**REMARKS**

**AMENDMENTS TO THE DRAWINGS**

**ANNOTATED SHEET SHOWING CHANGES**

FIG. 3B

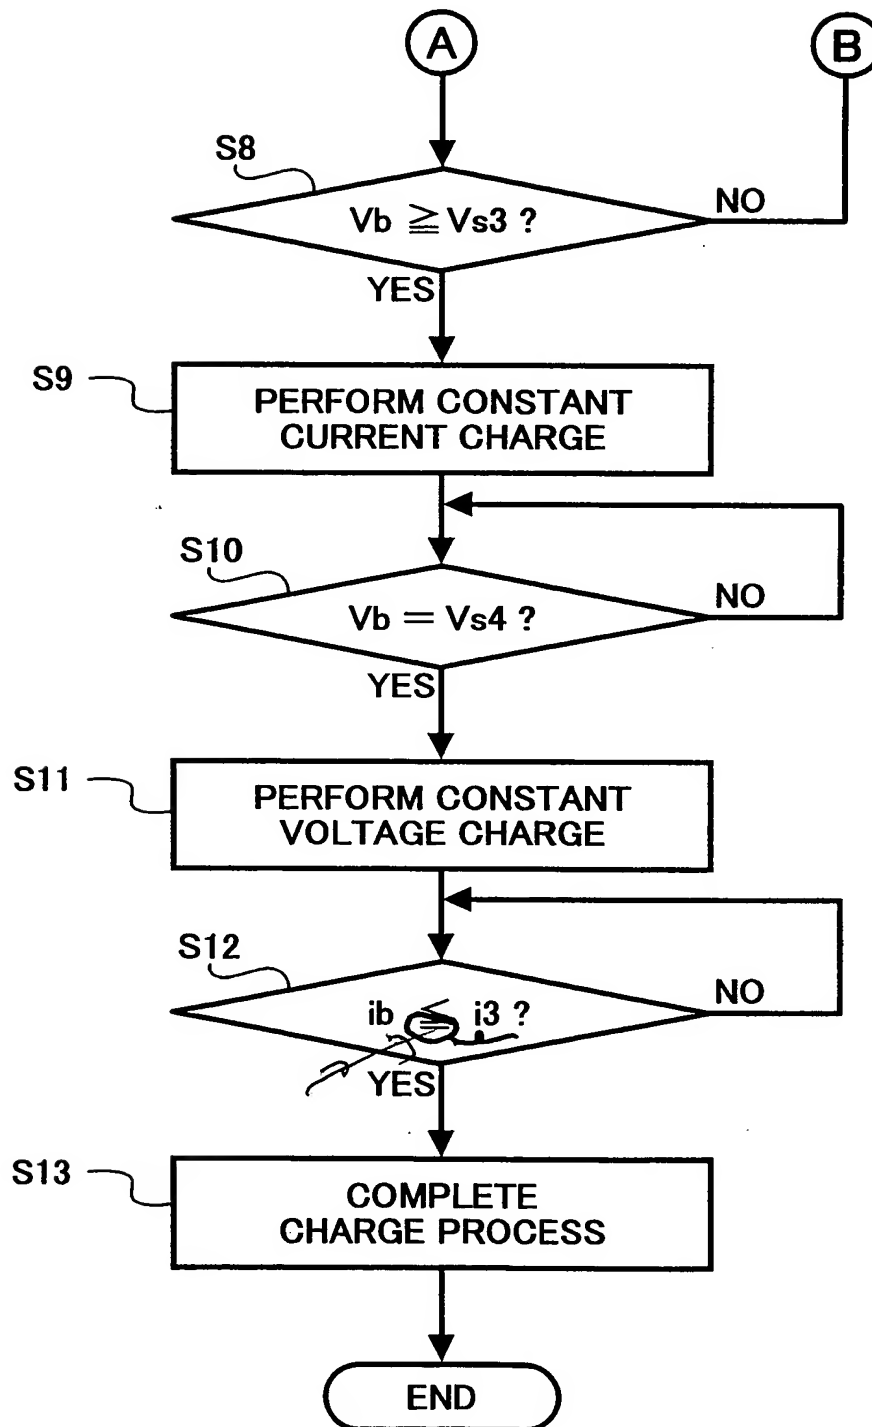
FIG. 3B has been changed to correct the inequality in Step S12. The inequality has been changed from " $i_b \leq i_3$ " to " $i_b < i_3$ ."
